335 Burnett Ave - Application for Fence Exemption

Date: March 21, 2024

To: North York Community Council

The purpose of this report is to consider an application by the owner(s) of 335 Burnett Ave to permit a proposed exemption to various section of the pool enclosure section of the Fence By law 447.

Attachment 5: Officers Photo – East side of the property viewing the inside fence of the pool enclosure of 335 Burnett Ave

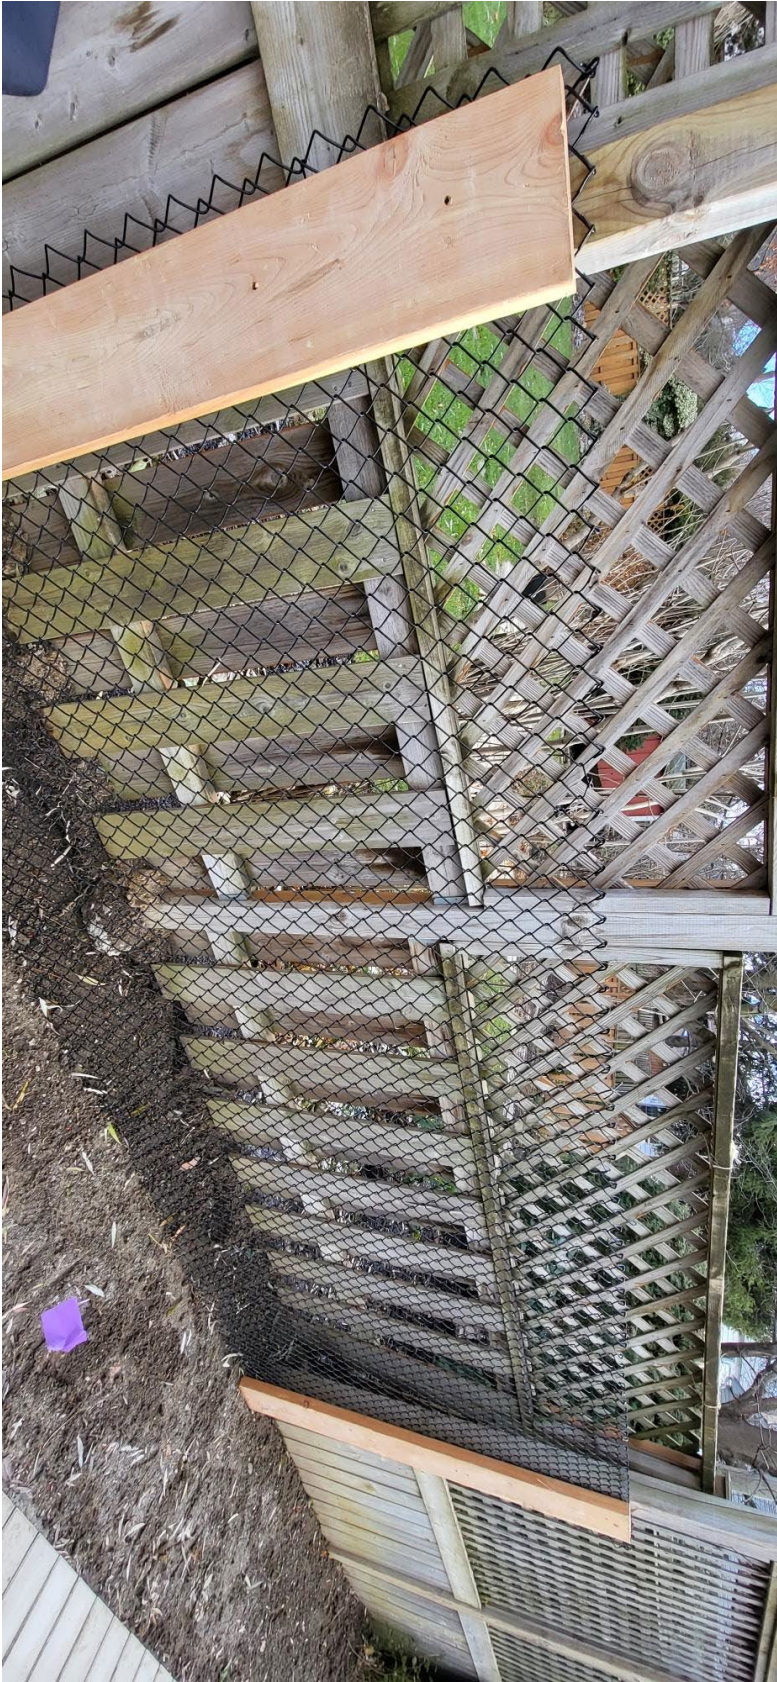
GENERAL LOCATION	SPECIFIC LOCATION	CONSTRUCTION & DEFICIENCY	BY-LAW SECTION & REQUIREMENT*
Rear Yard	Rear yard east wooden fence panels, one panel south and other north of the chain link panel.	Fence minimum height must be 1.2 meters. Wooden lattice is not an approved material to be considered part of the swimming pool enclosure fence and fence height.	Chapter 447 Section 447-1.3D.(1) The minimum height of a swimming pool enclosure above the highest outside grade within one metre of the enclosure shall comply with the following Table # 2 when measured at any point along the enclosure.
Rear Yard	Rear yard east wooden fence panel north of the chain link panel.	Height of swimming pool enclosure fence exceeds the height permitted by the Bylaw, namely 447-1.2B, Table 1. Namely; Rear yard east wooden fence panel north of the chain link panel.	Chapter 447 Section 447-1.2B Height of swimming pool enclosure fence exceeds the height permitted by the Bylaw

Rear Yard	Rear yard east fence panel, northwest fence panel and north fence panel just east of gate.	A chain-link fence used in a swimming pool enclosure shall be constructed in a good, workmanlike manner, cannot be attached with wooden boards as posts and must be well secured at the bottom of the fence.	Chapter 447 Section 447-1.3E.(2).(a) Swimming pool enclosure and gate made of chain-link material is not constructed in a good workmanlike manner
Rear Yard	Rear yard east chain link fence.	As specified in Table 3, the spacing of posts shall be to a maximum of 2.4 metres. Spacing greater than 2.4 meters and not approved material of posts.	Chapter 447 Section 447-1.3E.(2).(a) Swimming pool enclosure made of chain link material is constructed with posts spaced in excess of 2.4 metres.
Rear Yard	Rear yard east chain link fence.	As specified in Table 3, the spacing of posts shall be to a maximum of 2.4 metres. Spacing greater than 2.4 meters and not approved material of posts.	Chapter 447 Section 447-1.3E.(2).(a) Swimming pool enclosure made of chain link material is constructed with posts spaced in excess of 2.4 metres.

Rear Yard	Rear yard east chain link fence.	As specified in Table 3, the gate and end (terminal) posts shall be embedded in a minimum depth of 760 millimetres.	Chapter 447 Section 447-1.3E.(2).(a) Swimming pool enclosure made of chain-link material has posts embedded less than 760 millimetres below grade.
Rear Yard	Rear yard east fence panel, northwest fence panel and north fence panel just east of gate.	As specified in Table 3, the bottom wire shall be threaded through the mesh and looped and fastened to each post.	Chapter 447 Section 447-1.3E.(2).(a) Swimming pool enclosure made of chain-link material is constructed with bottom wire not threaded through the mesh and/or securely looped and fastened to each post.

Rear Yard	Rear yard east chain link fence.	As specified in Table 3, the diameter of the top rail and gate frame shall be a minimum standard of 32 millimetres. No top rail at all.	Chapter 447 Section 447-1.3E.(2).(a) Swimming pool enclosure made of chain-link material is constructed with top rail or gate frame diameter less than 32 millimetres.
Rear Yard	Rear yard west fence of 333 Burnett Ave, North York, ON within 1 meter of 335 Burnett ave, North York rear yard east fence swimming pool enclosure. As well as 56A Wentworth Ave, North York, ON rear yard north wooden fence that is shared with 335 Burnett ave, North York, OM.	A wood fence used in a swimming pool enclosure shall be constructed with vertical boards spaced at least 38 millimetres apart where horizontal rails are spaced less than 1.2 metres apart.	Chapter 447 Section 447-1.3E.(2).(b).[1].(b) Wood fence used in a swimming pool enclosure is constructed having spaces between the boards in excess of 38 millimetres where the horizontal rails are spaced less than 1.2 metres apart.

Rear Yard	Rear yard east wooden fence lattice panels. As well as 333 Burnett ave, North York, ON rear yard west wooden fence.	A wood fence used in a swimming pool enclosure shall be constructed with vertical boards shall be at least 19 millimetre by 89 millimetre lumber. Wooden lattice panels do not meet above dimensions.	Chapter 447 Section 447-1.3E.(2).(b).[1].(a) Wood fence used in a swimming pool enclosure is constructed with vertical boards with a minimum dimension of less than 19 millimetres by 89 millimetres.
Rear Yard	Rear yard east chain link fence panel.	Chain link fence must have vertical intermediate posts imbedded underground	Chapter 447 Section 447- 1.3E.(2).(a) Table 3 Swimming pool enclosure made of chain-link material is constructed with intermediate vertical posts 48mm in diameter.
Rear Yard	Rear yard enclosure chain link gate.	Chain link gate must be kept locked at all times except when the enclosed area is in use.	Chapter 447 Section 447- 1.3C.(6).(c){1}{2} Every gate in a swimming pool enclosure shall be self-closing and equipped

1. North York Community Council refuse to grant the application for an exemption permit, by the owner(s) of 335 Burnett Ave to permit a swimming pool enclosure in the rear yard of the property for an enclosure that fails to comply with the provisions of Toronto Municipal Code, Chapter 447, Fences and to direct staff to issue a notice to the property owner to bring the swimming pool enclosure into compliance.
